AGENDA
PLANNING AND ZONING COMMISSION MEETING
CITY OF CREVE COEUR, MISSOURI
TUESDAY, SEPTEMBER 3, 2013
7:00 PM

**CITY OF CREVE COEUR - MINUTES
PLANNING AND ZONING COMMISSION MEETING
MONDAY, AUGUST 19, 2013
7:00 P.M.**

**APPLICATION TO PLANNING AND ZONING COMMISSION
#13-003 FOR BOUNDARY ADJUSTMENT AND REZONING OF 5.26 ACRES
TO "CB" CORE BUSINESS DISTRICT, AND A CONDITIONAL USE PERMIT
FOR "THE VANGUARD OF AT CREVE COEUR" MULTI-FAMILY
RESIDENTIAL DEVELOPMENT**

Figure 2: Proposed Lot Configuration

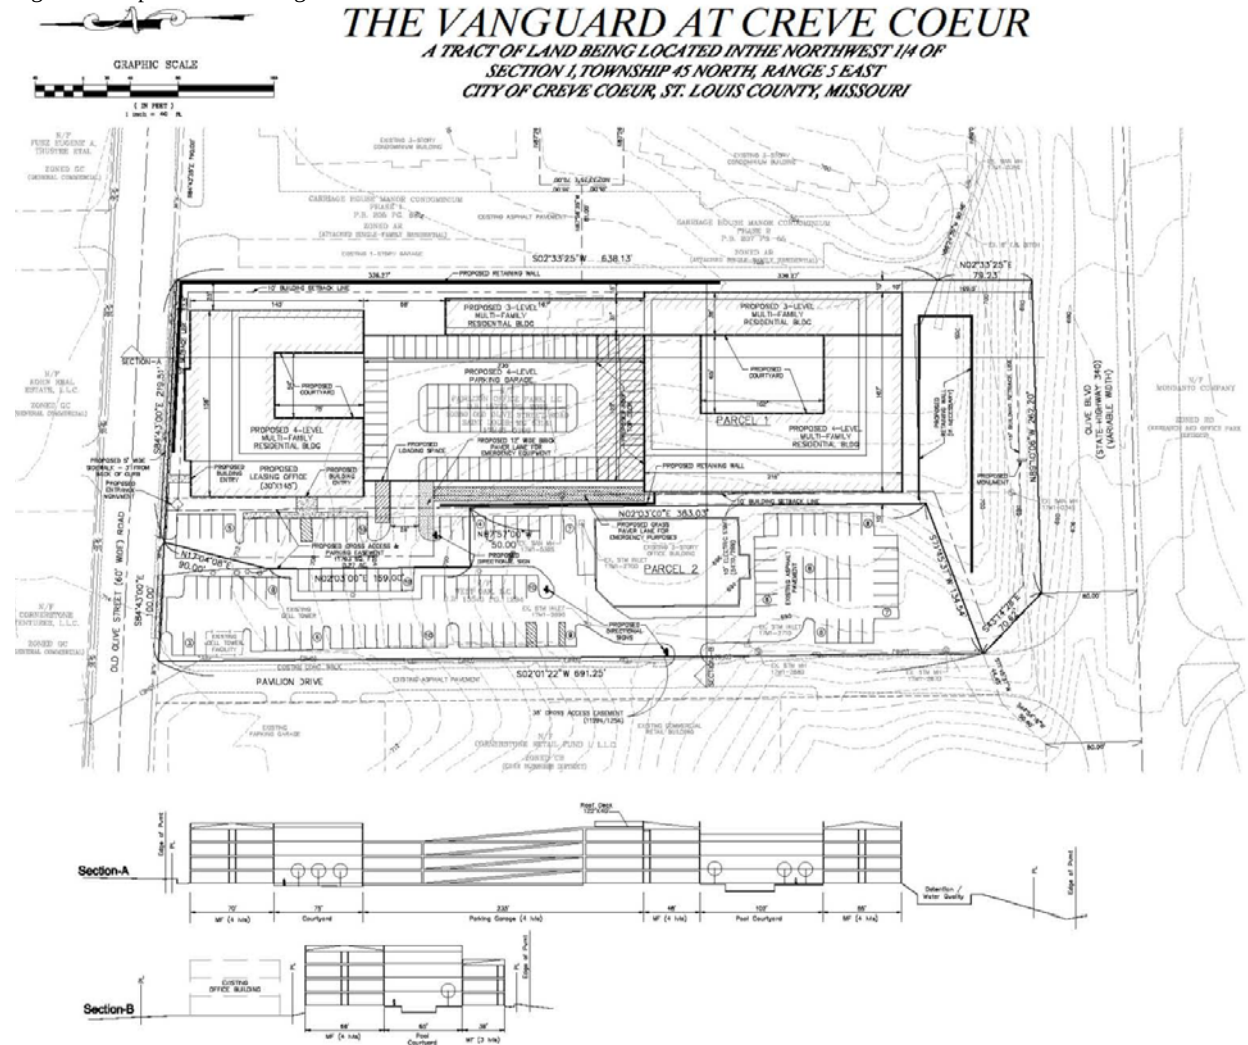
The proposal does include a boundary adjustment between the two lots although it is not shown on its own drawing. The effect of the adjustment is to increase the area of the apartments’ lot to at least three acres, while maintaining frontage on Old Olive Street Road for the office building. In the end, the sharing of access and parking across the property lines effectively obscures the distinctions between the properties, and the boundary adjustment should be viewed as a single project. It is typical in commercial developments, where there is a substantial sharing of facilities, for the property lines to largely follow economic priorities rather than a simple, conventional lotting pattern. The site development drawing appears to meet the technical requirements for a boundary adjustment so the adjustment can be approved subject to the condition that a final boundary adjustment plat be prepared for signature prior to recording.

Figure 5: South & North Elevations

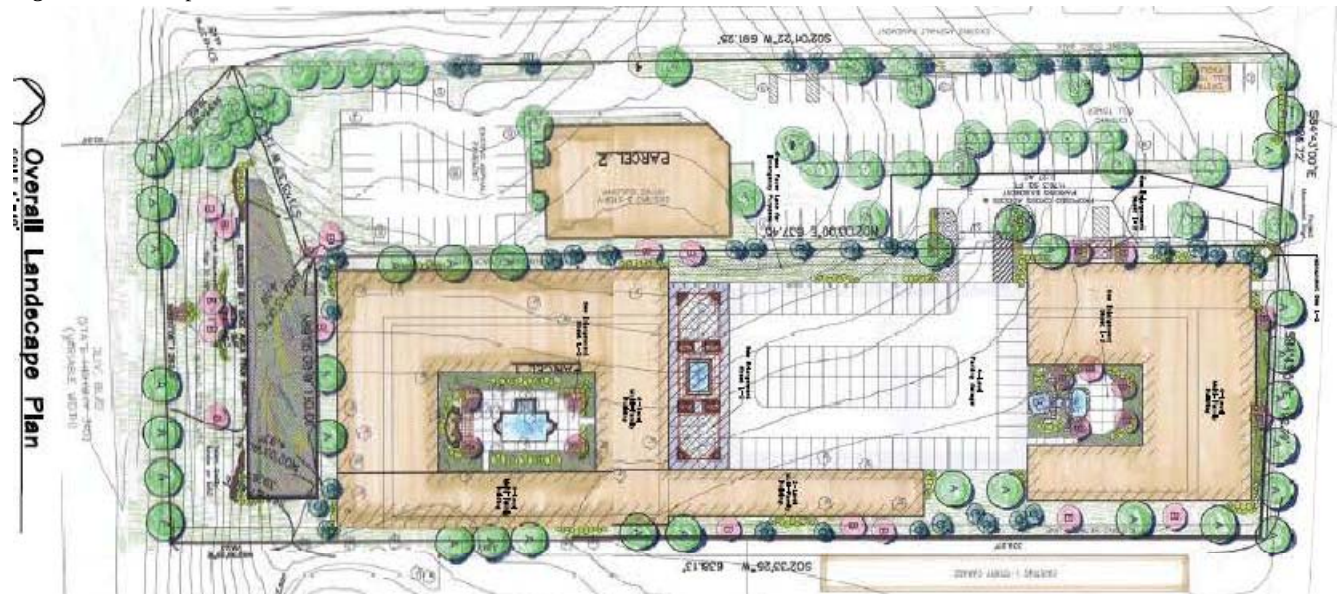
The revised structure has a greater articulation of elevations and variety in the roof-line that is recommended by the Design Guidelines. All sides of the building have equal merit, and the landscape along Olive Boulevard has been revised to include the required street trees and a mix of ornamental trees and shrubs on the hillside to more closely address the “green-line park” objective for Olive Boulevard. Currently, MoDOT does not recommend the installation of sidewalks along Olive Boulevard in this location since there are no pedestrian facilities on the Olive Boulevard bridge over Lindbergh Boulevard. It is their preference that all pedestrians move only to the west via Old Olive Street Road. Appropriately, the applicant is proposing street trees along Old Olive Street Road and a new, detached sidewalk is still included. Finally, the surface parking lot shared with the adjacent office building includes extensive interior landscaping and planted breaks in the rows of parking stalls.
